**From:** David Peacock [mailto:DavidPeacock@jswright.co.uk]  
**Sent:** 04 September 2015 12:06  
**To:** Hugh Mahoney <hm@psbuk.com>  
**Cc:** Jonathon Earl <JonathonEarl@jswright.co.uk>  
**Subject:** FW: Grenfell Tower - AOV

# Smoke Ventilation Technical submission

## Lobby Smoke Control Systems

## Grenfell Tower Apartments, London

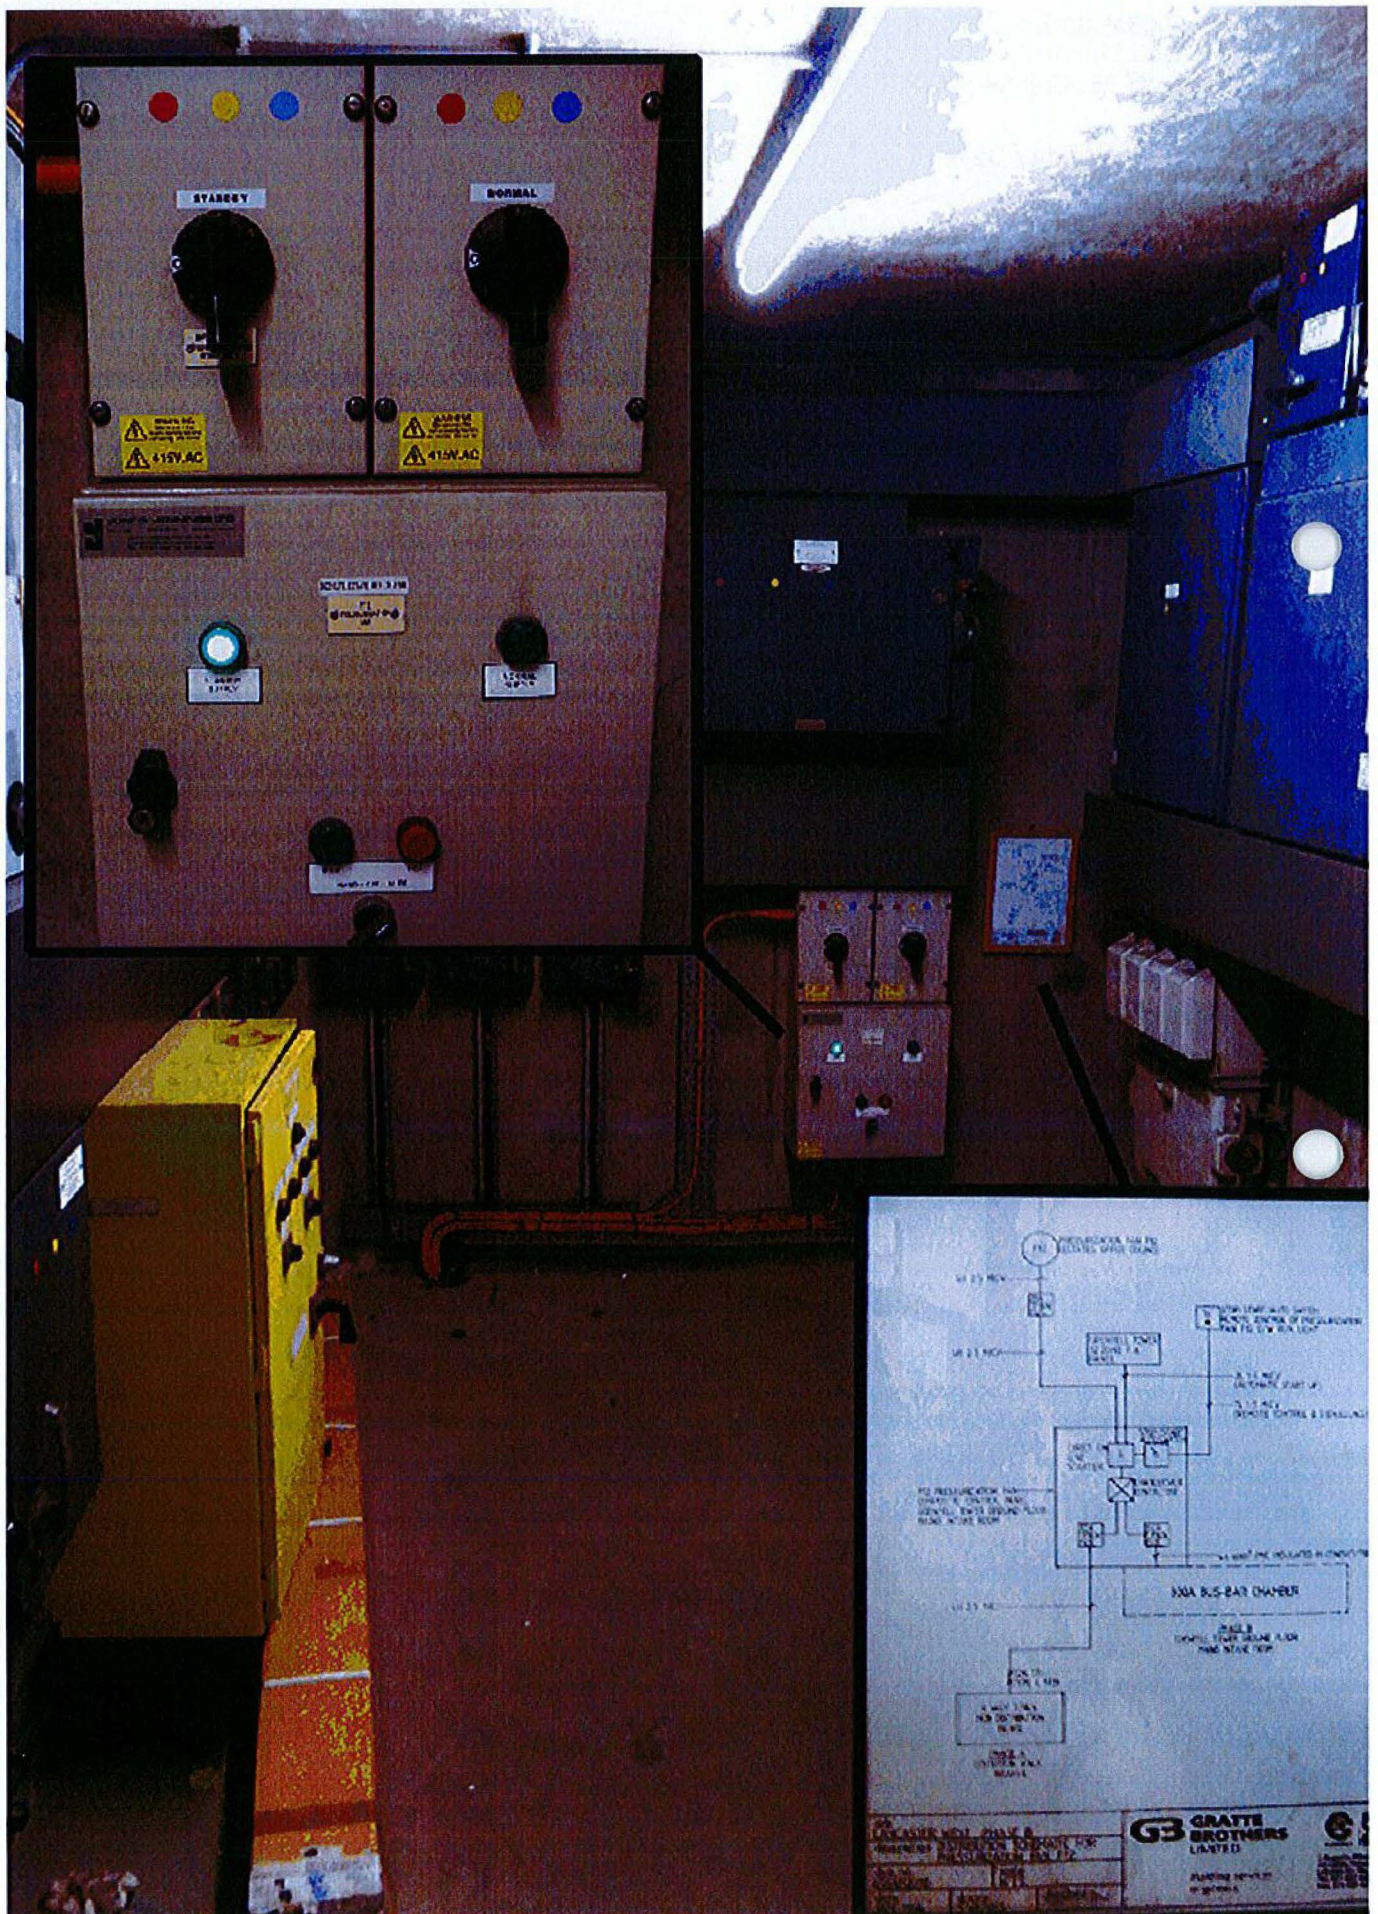
2) With regard to secondary supply into the building, the Fordham tender drawings indicate an existing supply from Testerton Walk - Intake 6:

- Matt, can you confirm that Fordham's actually picked this up in their survey, I have been looking into this in more detail today, I couldn't locate the secondary supply, but also found a large battery inverter bank that appears to be providing the secondary supply for the existing smoke vent system. Can you shed any light on this?
- Notwithstanding the above, the supply indicated from Testerton Walk appears to be single phase only, as is the existing inverter system. As you are aware the new PSB smoke vent system is based on a 400V 3-phase system. Therefore it's unlikely either of the existing secondary supply options are going to be suitable.

2) This was picked up in our survey. Please see annotated image below of the switch room at Grenfell and attached image files:
